TITLE: Pelican 1610 Transport Case Design Refinements

PRODUCTS AFFECTED: Pelican's 1610 Protector™ Cases

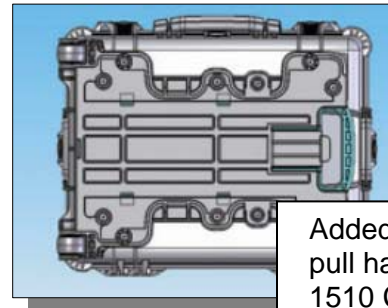
Added overmolded front and side handles

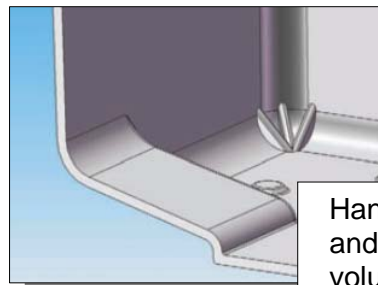
Added one-handed-action pull handle dolly (Similar to 1510 Carry On and 1560)

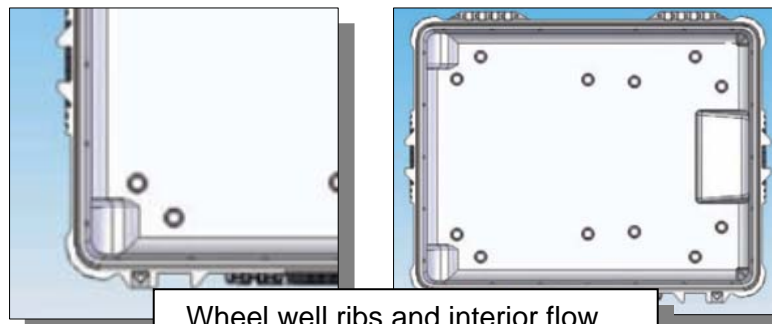
Inside wall thickness removed behind purge valve area to increase internal volume

Handle recess area deepened and narrowed – less internal volume

Wheel well ribs and interior flow channels removed to increase internal capacity
